**SUBJECT: AMBIENT AIR QUALITY MODELING
PROTOCOL for ANDGAR CORPORATION,
KETTLE BUTTE DAIRY
20 NORTH 2100 EAST
ROBERTS, IDAHO 83444**

RE: Modeling Protocol for an Anaerobic Digester and Generators at Kettle Butte Dairy near Roberts, Idaho

SITE DETAIL

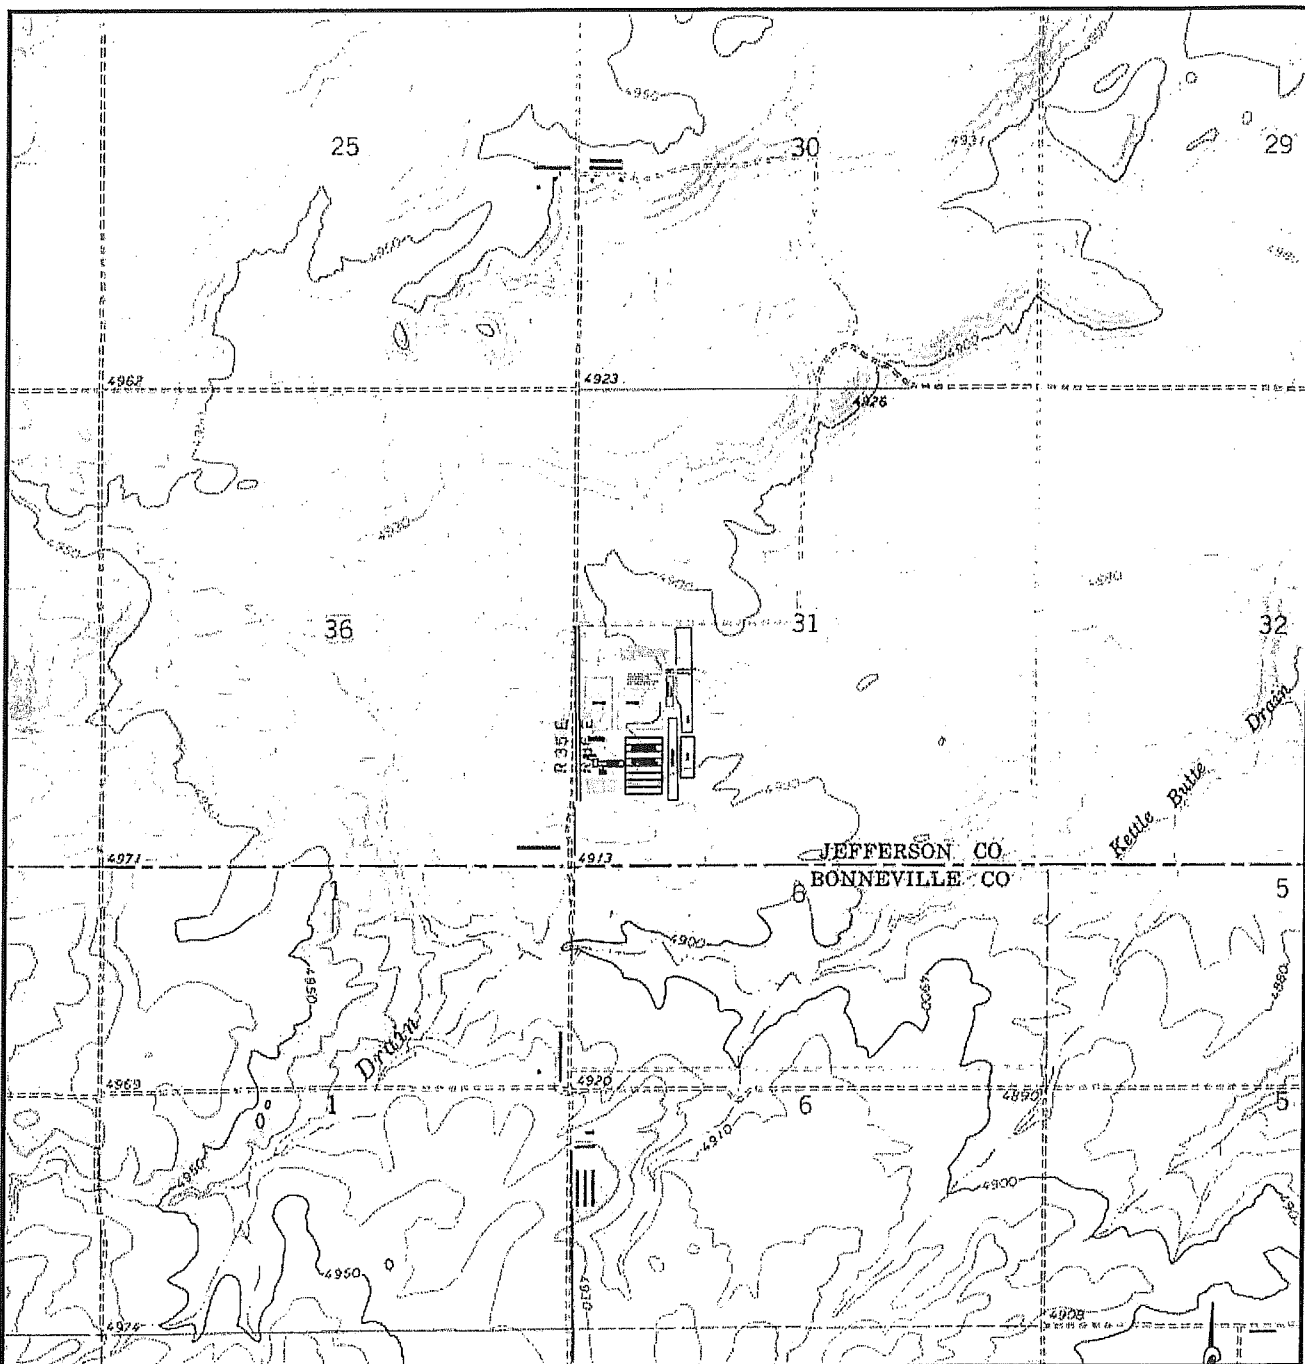
- Comment 1: Facility Definition and Ambient Air Boundary. The protocol asserts the digester and generators will be a separate facility from the Kettle Butte Dairy, and that Cargill Environmental Finance will be leasing space on Kettle Butte's property. If these are separate facilities, then the ambient air boundary will be the boundary of the leased property rather than the property boundary of the dairy, as described in the protocol.
